**CERTIFICATE OF APPROPRIATENESS**

**Applicant:** Greg Swedberg, 2 Scale Architects, for Ed Love, owner

**Property:** 417 Travis Street, Tract 6, Block 44, SSBB Subdivision. The property includes a historic 3,800 square foot two-story midblock commercial structure situated on a 2,600 square foot (26' x 100') interior lot.

**CONNECTOR HALL**

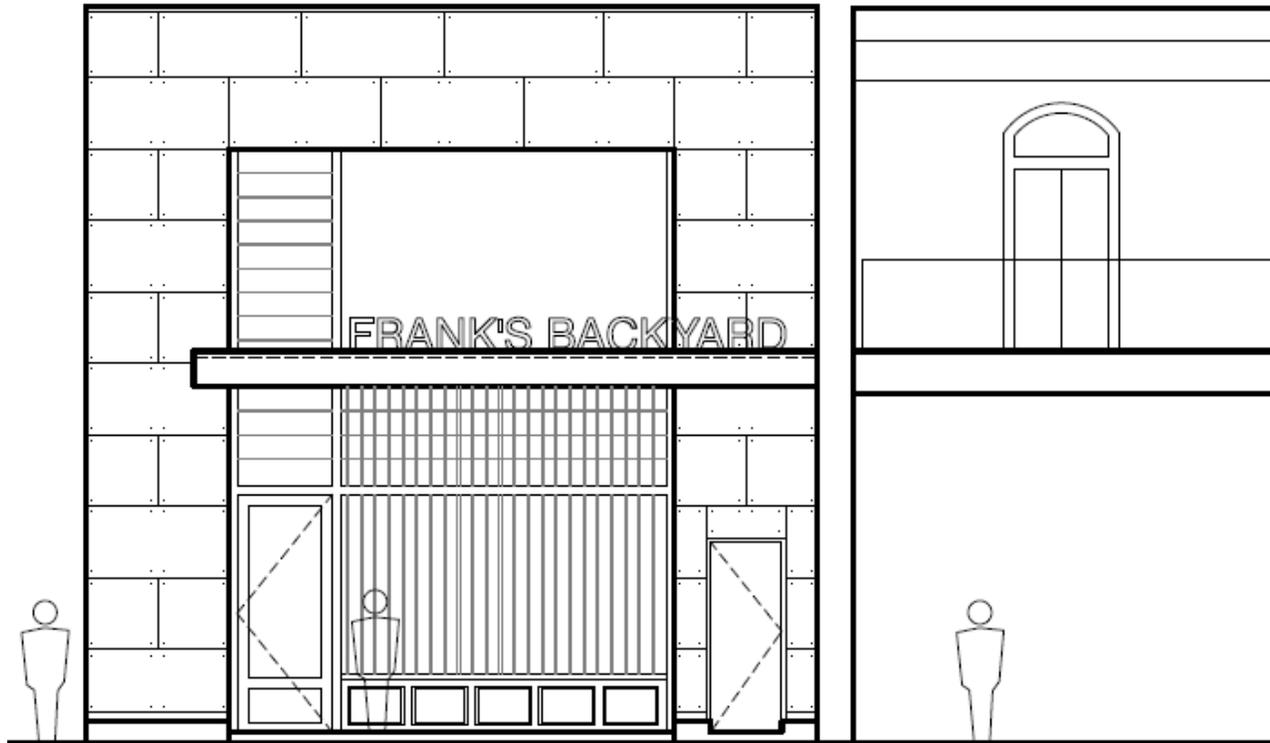
**Shape/Mass:** 417-419 Travis is not sitting squarely on its property line, leading to a small gap between existing historic building at 417 and the proposed adjacent structure; a connector hall will bridge that small gap. The proposed 6" deep and approximately 5' wide CMU waterproofed connector hall, with a parapet height of 17.5' above finished floor, will be constructed to connect the existing building at 417 Travis to the proposed structure at 413 Travis. See drawings for more detail.
